SERVICE BULLETIN

LANDING GEAR - BRAKE CONTROL UNIT REPLACEMENT

This service bulletin supersedes SB505-32-0006

FIGURE 1 - BRAKE CONTROL UNIT REPLACEMENT
(SHEET 01 OF 01)

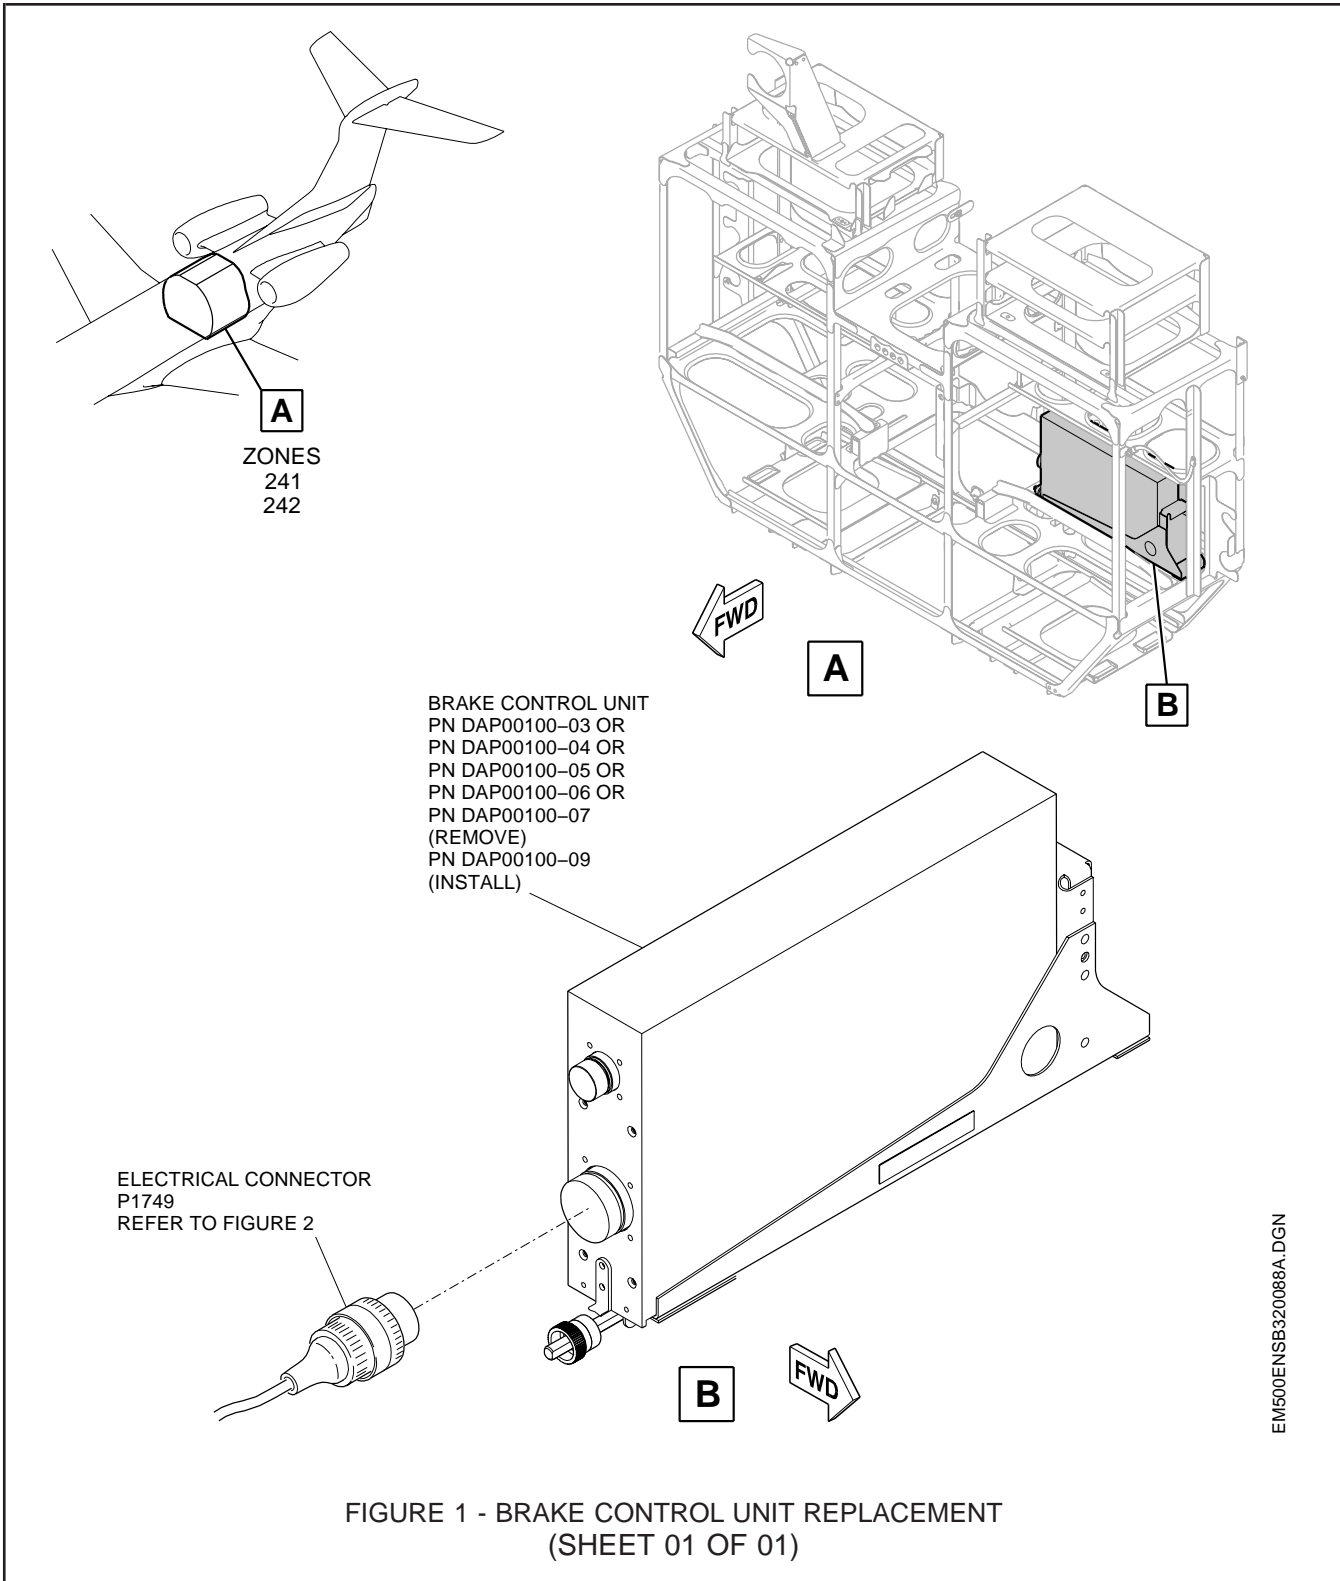
This service bulletin consists of the replacement of the BCU currently installed (PN DAP00100-03, or PN DAP00100-04, or PN DAP00100-05, or PN DAP00100-06, or PN DAP00100-07) with a new improved one, bearing PN DAP00100-09, and a modification to the electrical connector P1749.

- A. Make sure that the aircraft is safe for maintenance. Refer to [AMM TASK 20-00-00-910-801-A/200](#) - Aircraft Maintenance Safety Procedures.
- B. Remove BCU (Brake Control Unit) PN DAP00100-03, or PN DAP00100-04, or PN DAP00100-05, or DAP00100-06, or PN DAP00100-07, as applicable, according to [AMM TASK 32-41-01-000-801-A/400](#) - Brake Control Unit - Removal. Refer to [Figure 1](#).

- E. Install BCU PN DAP00100-09 according to [AMM TASK 32-41-01-400-801-A/400](#) - Brake Control Unit - Installation. Refer to [Figure 1](#).
- F. Do the test of the electrical modification as follows:

FIGURE 2 - P1749 ELECTRICAL MODIFICATION
(SHEET 02 OF 02)

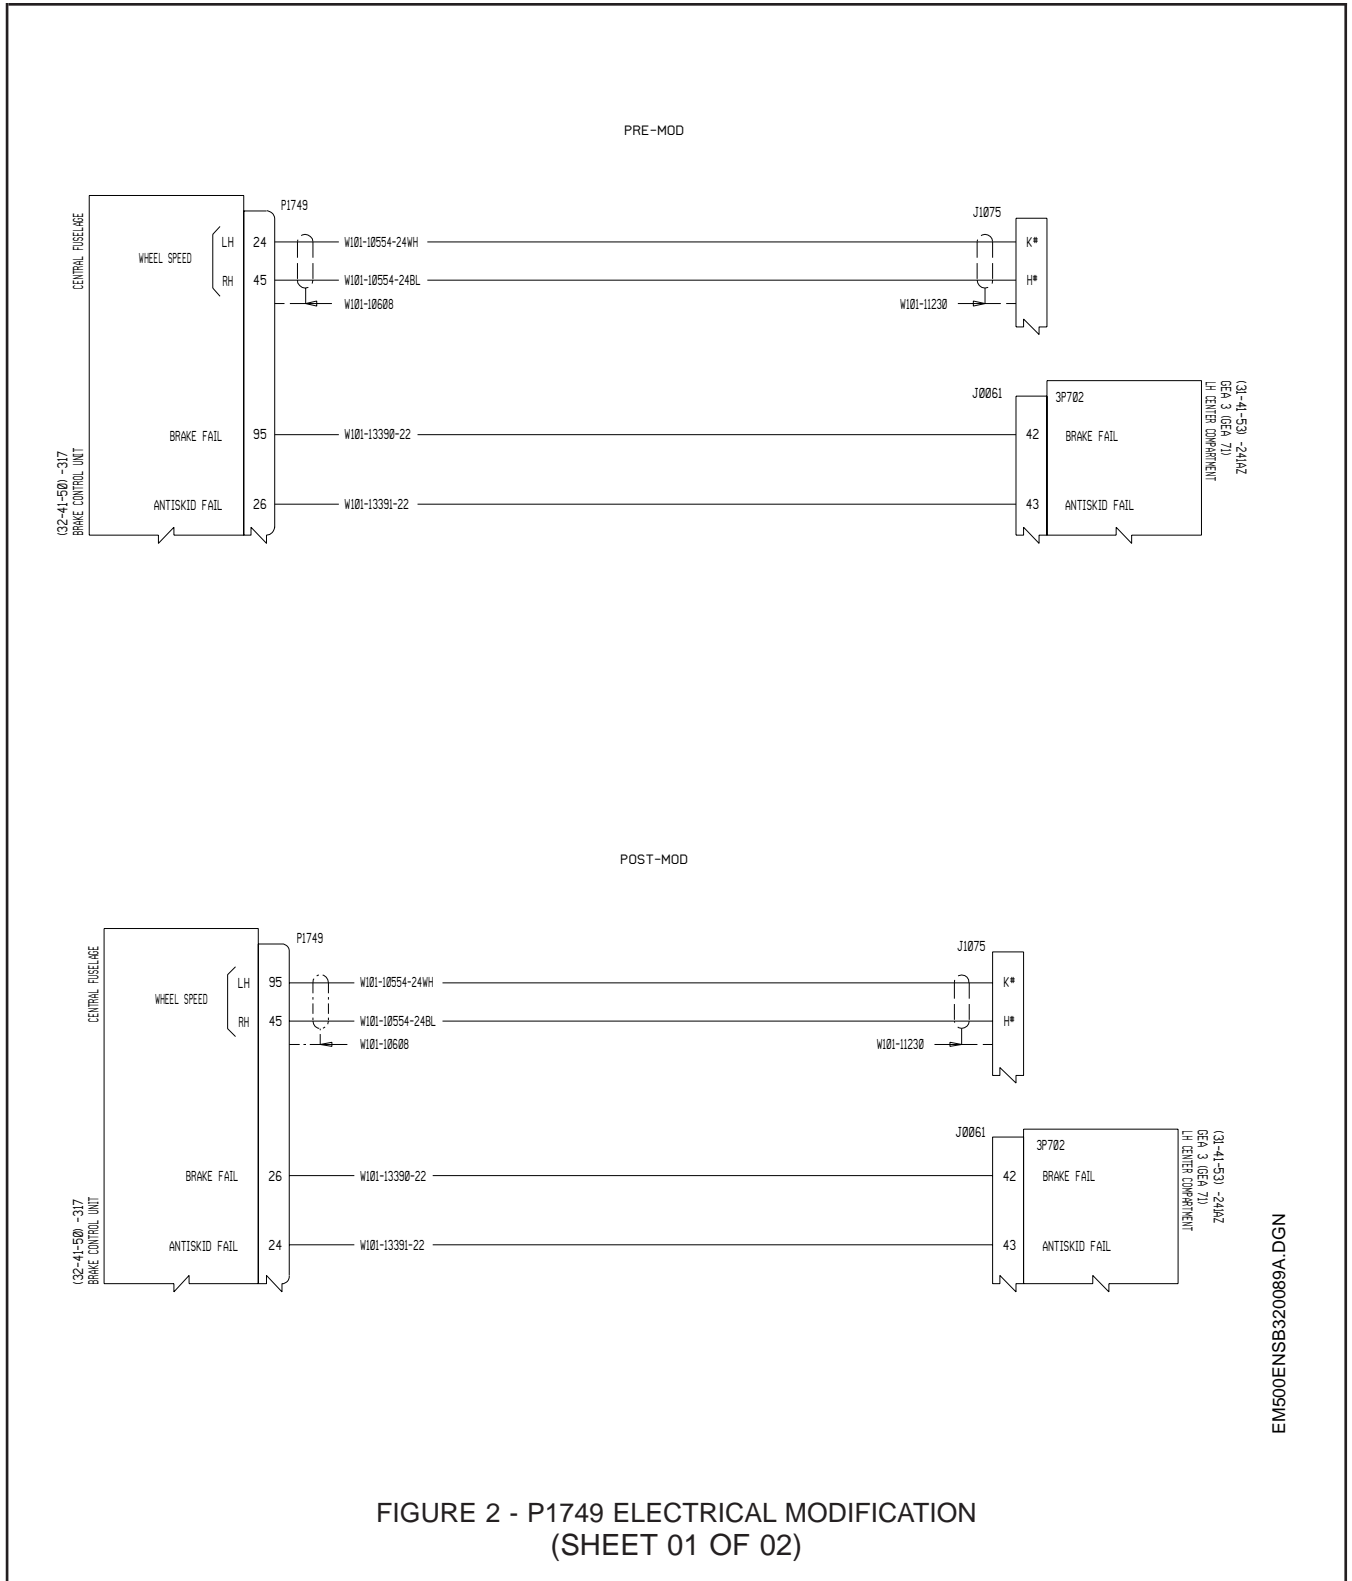
- C. Send the removed BCU to one of the addresses presented in [Item 2.C.\(1\)](#)
- D. Carry out the electrical modification on the BCU electrical connector P1749 according to [Figure 2](#) and [SWPM 20-21-20](#) - Contact Insertion and Removal Tools - Maintenance Practices.

ACTION	WIRE IDENTIFICATION	ITEM 1	PIN 1	CODE 1	ITEM 2	PIN 2	CODE 2	TYPE	EMC
MOD (PRE)	W101-10554-24WH	J1075	K#	CBM	P1749	24	CBG	EB	S
MOD (POST)	W101-10554-24WH	J1075	K#	CBM	P1749	95	CBG	EB	S
MOD (PRE)	W101-13390-22	J0061	42	CPP	P1749	95	CBG	AA	S
MOD (POST)	W101-13390-22	J0061	42	CPP	P1749	26	CBG	AA	S
MOD (PRE)	W101-13391-22	J0061	43	CPP	P1749	26	CBG	AA	S
MOD (POST)	W101-13391-22	J0061	43	CPP	P1749	24	CBG	AA	S

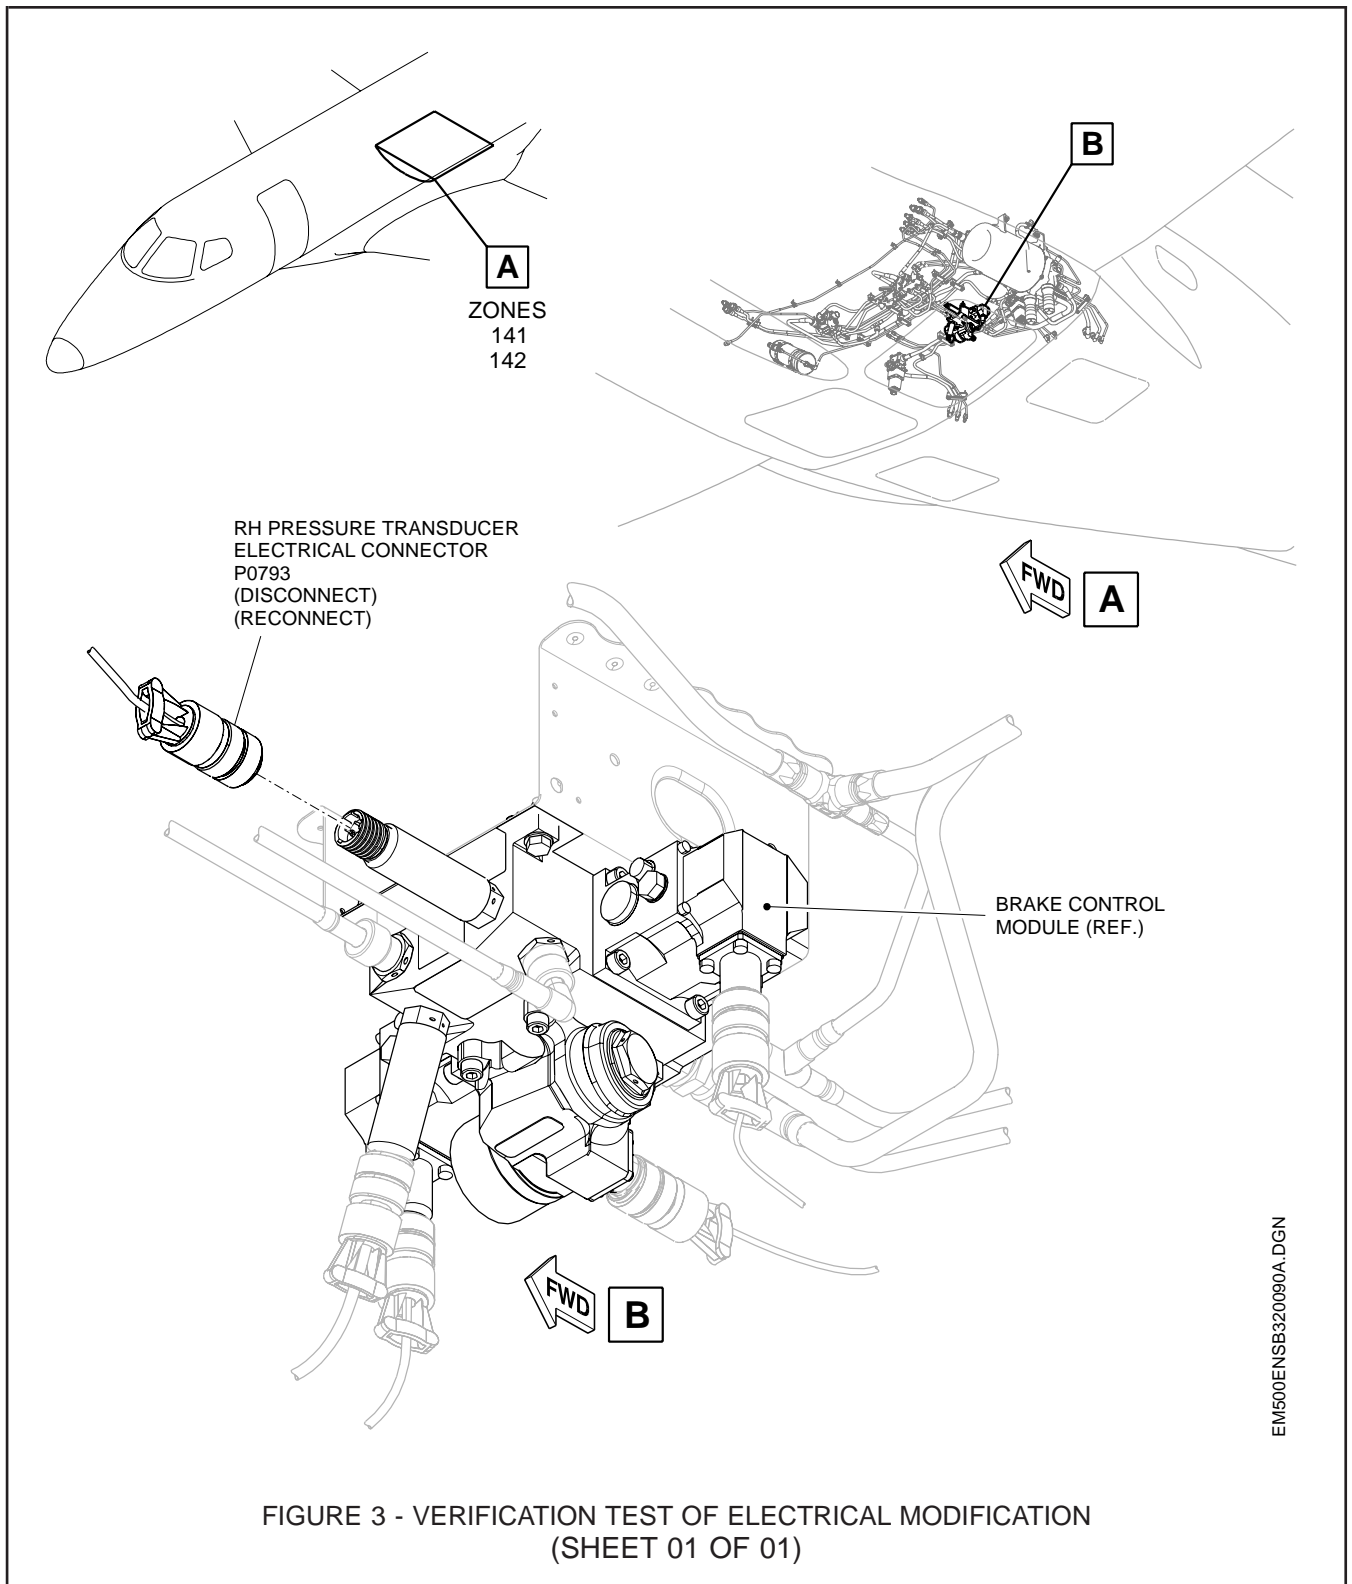
- (5) Disconnect the electrical connector P0793 (RH Pressure Transducer) from BCM (Brake Control Module). Refer to [Figure 3](#).

- (6) Open the circuit breaker BRAKE - RHCBP (EMERGENCY BUS) of the BCU.
 - (7) Reconnect the electrical connector P0793 (RH Pressure Transducer) of the BCM (Brake Control Module). Refer to [Figure 3](#).
